RENESAS TECHNICAL UPDATE

Product Category	MPU/MCU		Document No.	TN-R8C-A016A/E	Rev.	1.00
Title	le Notes on R8C Family (2)		Information Category	Technical Notification		
Applicable Product	R8C/1x Series R8C/2x Series R8C/3x Series R8C/Lx Series	Lot No.	Reference Document			
	g notes have been added to the hardwar to the hardware user's manual for applica		l. The functions	described below do no	t exist ir	n som
This note When in	en inputting an externally generated clock e applies to the R8C/3x Series. putting an externally generated clock from nd the CM12 bit in the CM1 register to 1 (c	n the XCIN pin,	set the CM03 b	-	0 1 (XCII	N cloc
The time The time	timer X and timer RA er X note applies to the R8C/1x Series. er RA note applies to the R8C/2x Series, R set 00h to the TX register or TRA registe				d measu	remer
This note When us TEND b immedia instructio While us	synchronous serial communication unit (S e applies to the R8C/1x Series, R8C/2x Se sing the SSU, a maximum of three cycle bit or TDRE bit in the SSSR register to ttely after writing to the SSTDR register, ons. sing the I ² C bus interface, when reading th RT register, insert more than three NOP ins	eries, R8C/3x Se s are

Procedure for enabling reduced internal power consumption using VCA20 bit in the VCA2 register 4

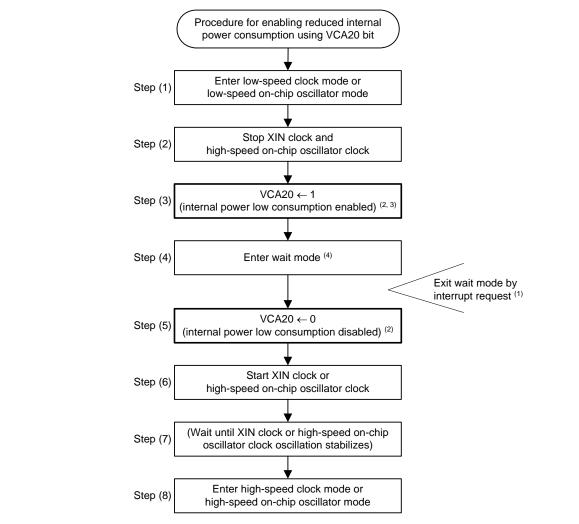
The procedure when the MCU enters wait mode by setting the CM30 bit in the CM3 register to 1 is shown below.

Note: The procedure described in the hardware user's manual assumes the MCU enters wait mode by executing the WAIT instruction.

1. After entering wait mode by the CM30 bit, when an interrupt request is generated, without performing interrupt handling,

start the execution from the instruction immediately following the instruction to set the CM30 bit to 1.

2. Do not set the VCA20 bit to 0 with the instruction immediately after setting the VCA20 bit to 1. Also, do not do the opposite. When the VCA20 bit is set to 1, do not set the CM10 bit to 1 (stop mode).
When the MCU enters wait mode, comply with the information in the Wait Mode chapter in the hardware user's manual.
